WOLLONGONG CITY COUNCIL

# Traffic Committee Minutes of Meeting

14 November 2023

Item 2.10 – WOLLONGONG, Burelli Street – Disabled Parking Space

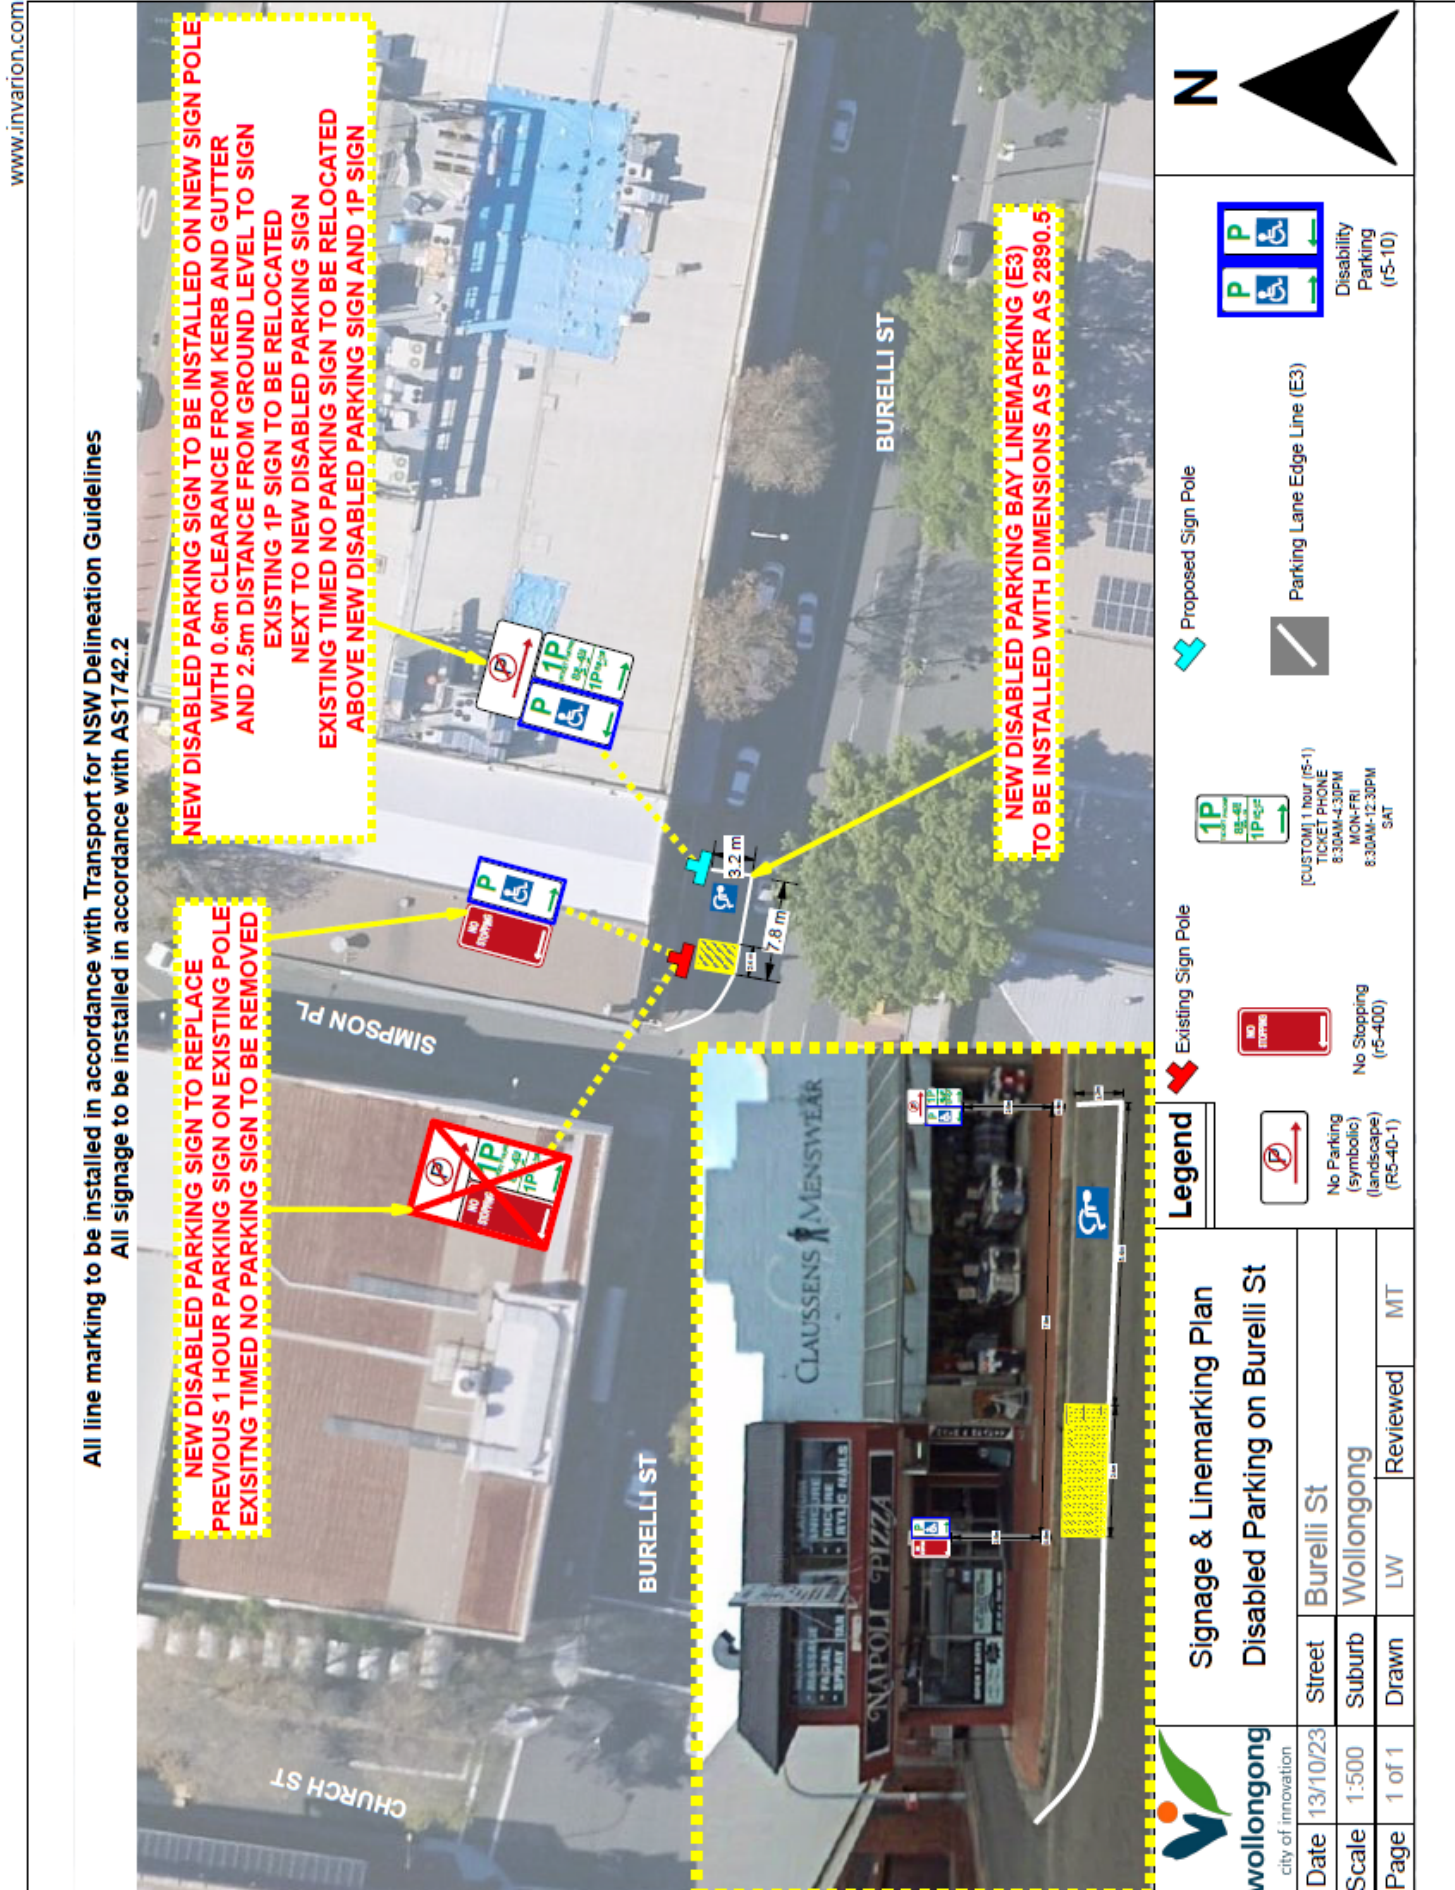
Council has reviewed the traffic conditions at Burelli Street, Wollongong (specifically the section between Church Street and Kembla Street). Currently, the section of road does not provide any Disabled Parking spaces with an existing row of timed 1P Parking available on the kerbside.

It is proposed to install one Disabled Parking space with reference to AS 2890.5:2020 – Parking facilities – Part 5: on-street car parking. It is acknowledged that the proposal is not fully in accordance with AS 2890.5:2020, since there are challenges with installing a compliant kerb ramp, however, this has been added to Councils Infrastructure Delivery Program Priority List for programming at a later date.

The attached Disabled Parking Plan on Burelli St V4 be approved.

Item 2.11 – BERKELEY, Kelly Street – Sign Installation

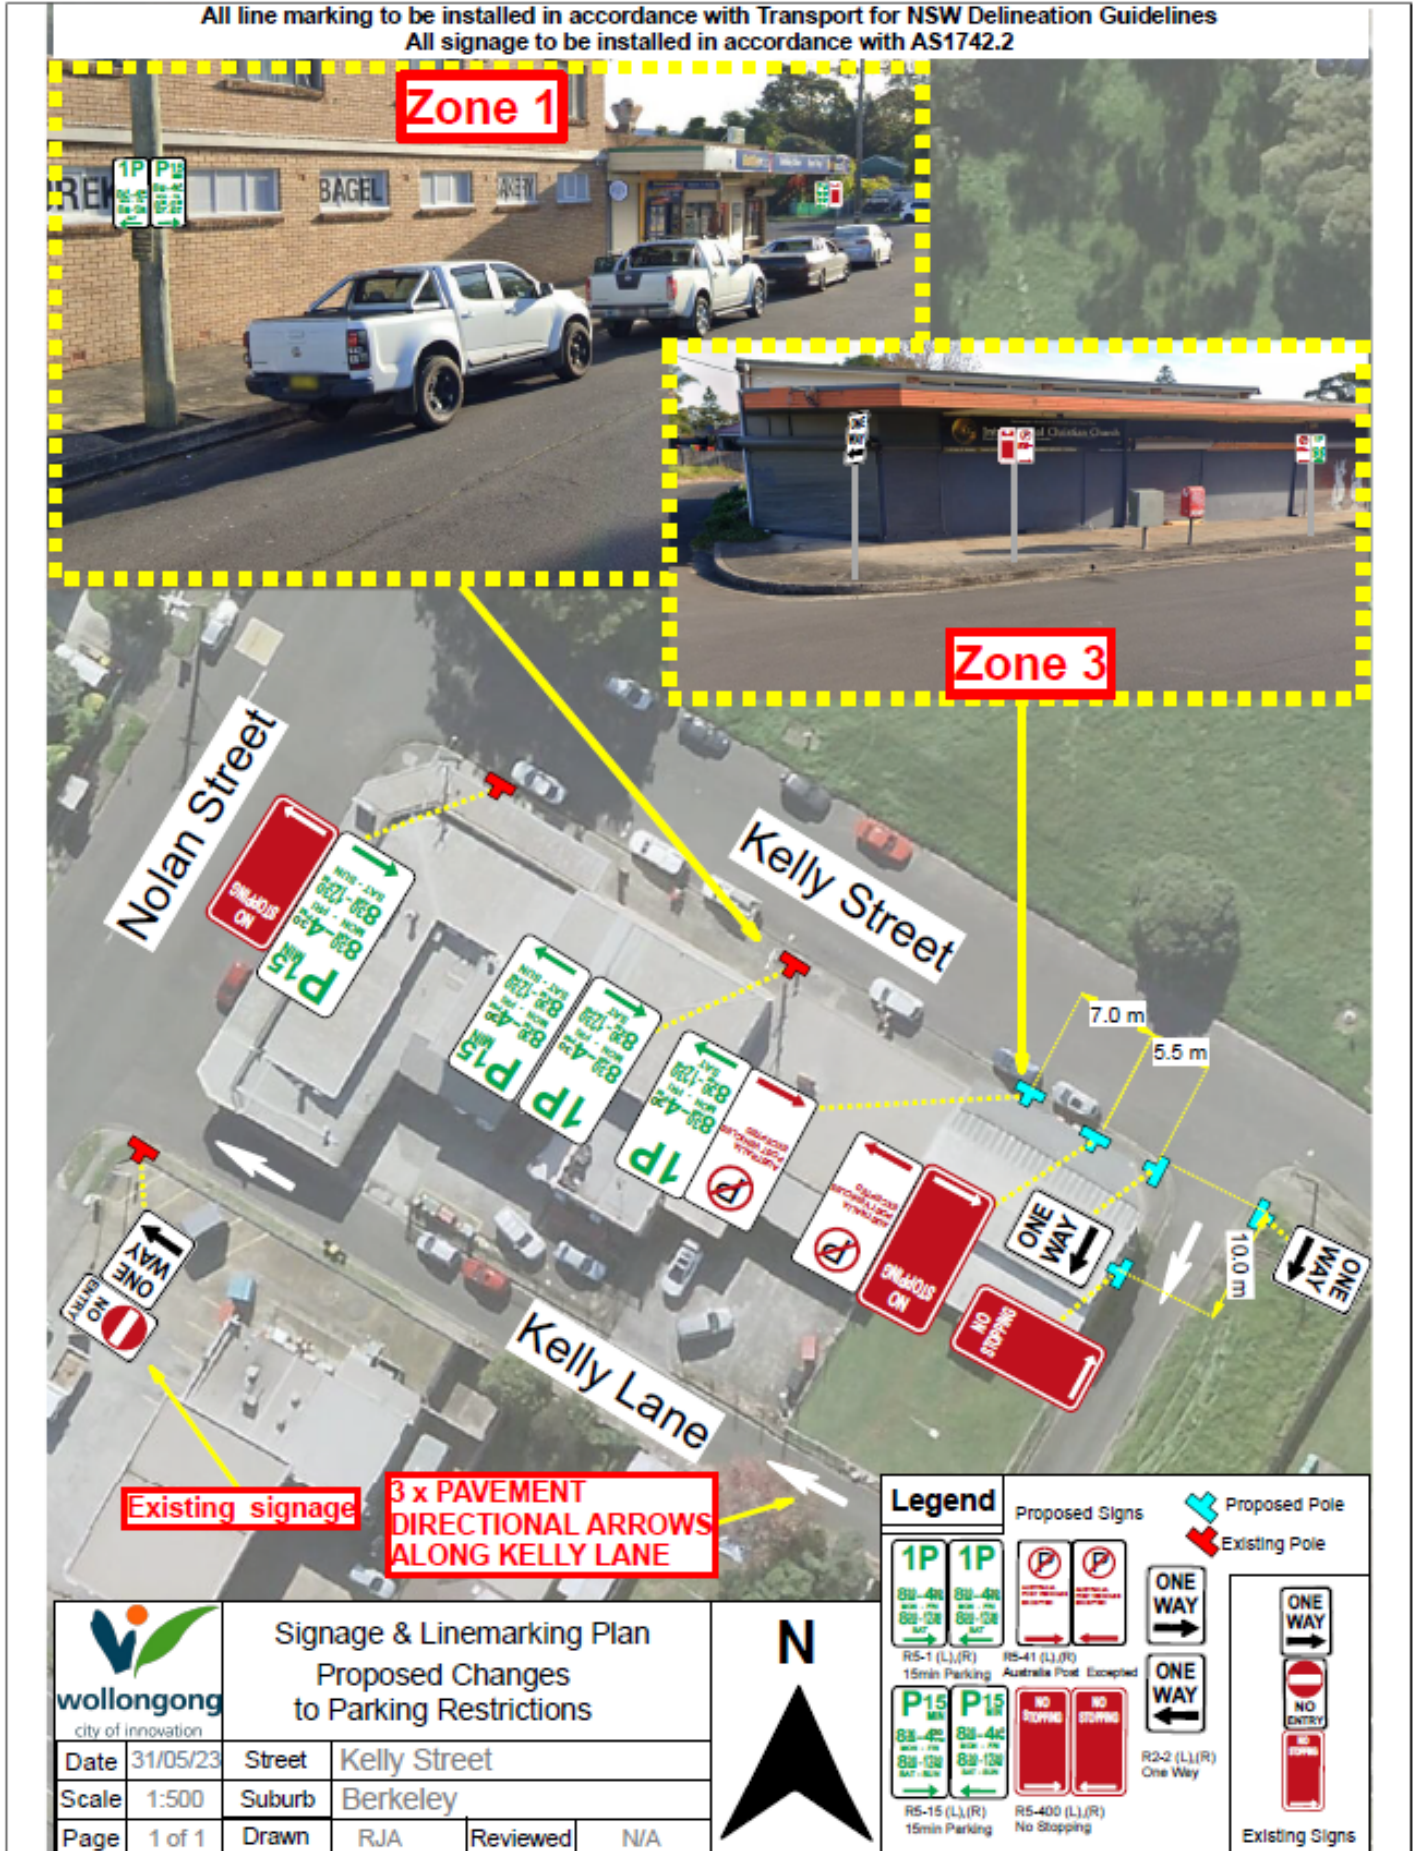
To improve business turnover and to address concerns raised during the consultation rounds, Council aims to provide a balanced approach to ensure that turnover of car parking spaces occur on a Sunday whilst retaining some unrestricted spaces in front of 2 – 6 Kelly Street.

To achieve this, Council proposes to change the all-day parking spaces on the Kelly Street frontage to three separate parking zones:

- Zone 1 - 15min parking, 8:30am – 4:30pm, MON – FRI, 8:30am – 12:30pm, SAT – SUN,
- Zone 2 - 1-Hour parking, 8:30am – 4:30pm, MON – FRI, 8:30am – 12:30pm, SAT,
- Zone 3 - "No Parking – Australia Post Vehicles Excepted" zone in front of the post box which will cater for Australia Post requirements as well as provide a pick-up/ drop-off area.

The attached plan be approved.
